**RAI 03.07.01-27, Supplement 1, Revision 1**

**Follow-up Question to RAI 03.07.01-19 (STP-NRC-100093)**

**REVISED SUPPLEMENTAL RESPONSE:**

**RAI 03.07.01-27, Supplement 2, Revision 1**

**Figure 3H.6-231: SSI, SSSI, ASCE 4-98 and Design Lateral Seismic Soil Pressures on Diesel Generator Fuel Oil Storage Vault No. 1A West Wall**

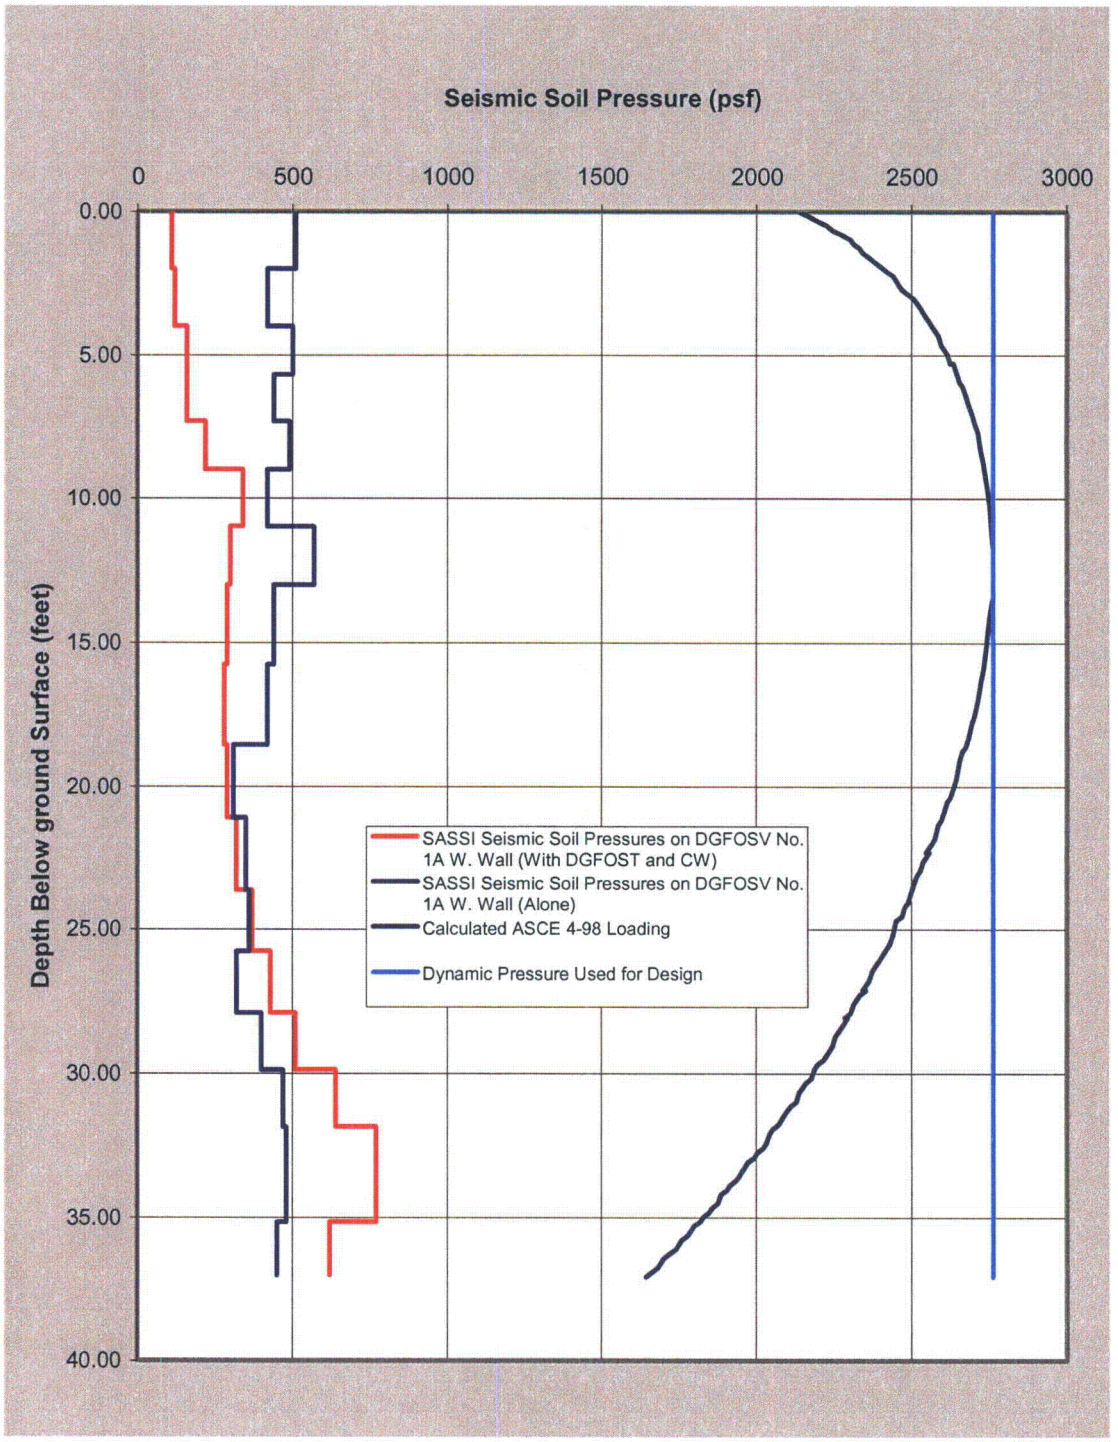
(c) Demonstrate that the DGFOSV foundation response spectra and dynamic soil pressure (on DGFOSV basement walls using ASCE 4-98 criteria) used in the design of DGFOSV will envelop the results of structure to structure (SSSI) interaction analysis which explicitly models DGFOSV structure in the SSI model of RB and the RSW Pump House structure.

1. Clarify that the seismic soil pressures in Figures 3H.6-226 to 3H.6-231 are incremental seismic soil pressures.
2. Clarify that all walls of the diesel generator fuel oil storage vaults are designed for incremental seismic soil pressures shown in Figures 3H.6-226 to 3H.6-231.
3. Clarify how the diesel generator fuel oil tank was modeled in the soil-structure interaction analyses of the diesel generator fuel oil storage vaults.

The structural analysis and design of the DGFOSV have been revised to consider incremental seismic soil pressures from the SSSI analysis described in part 1a above. Figures 3H.6-226 through 3H.6-231 show a comparison of the incremental seismic soil pressures obtained from SSSI and the ASCE 4-98 methodology and the incremental seismic soil pressure used in the design of all DGFOSV walls. The revised design results for the DGFOSV will be provided in the response to RAI 03.08.04-30, Revision 1, which is currently scheduled to be submitted by March 15, 2011.

**Figure 3H.7-20: 2D Model for SSI Analysis of a Typical Cross section of DGFOT**

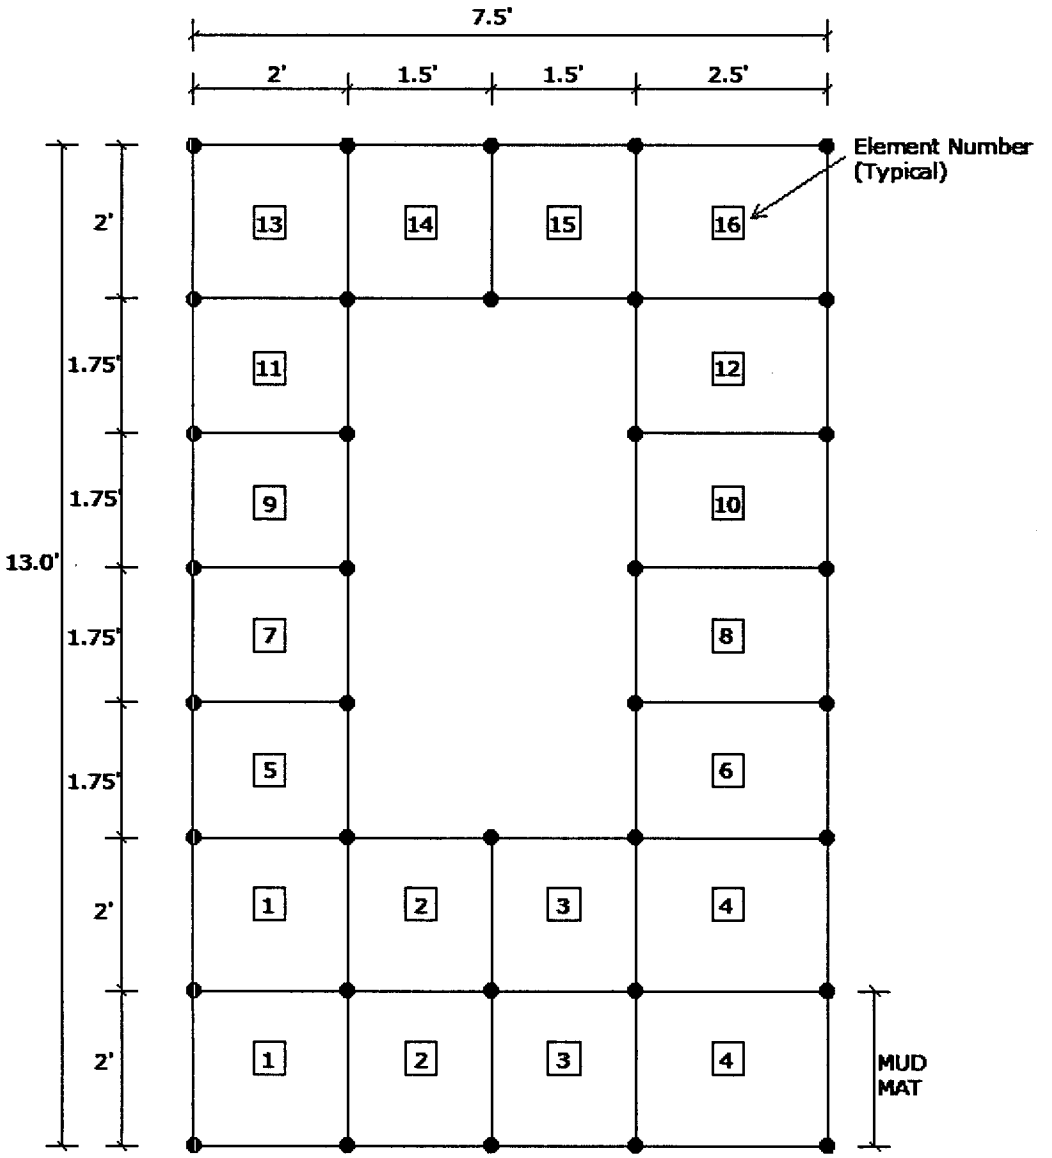
(d) Describe in detail if there is any Category I tunnel structure for transporting Diesel Fuel Oil between DGFOSV and the Diesel Generator located in other buildings including its layout and configuration and seismic analysis and design method.

SASSI2000 computer code is used for the SSI analysis, using the direct method. Figure 3H.7-20 shows the structural part of the 2D plane-strain model of the DGFOT with 2 ft thick mud mat under the base mat. The top of the tunnel is at the grade elevation. The specifics of the 2D SSI model are as follows:
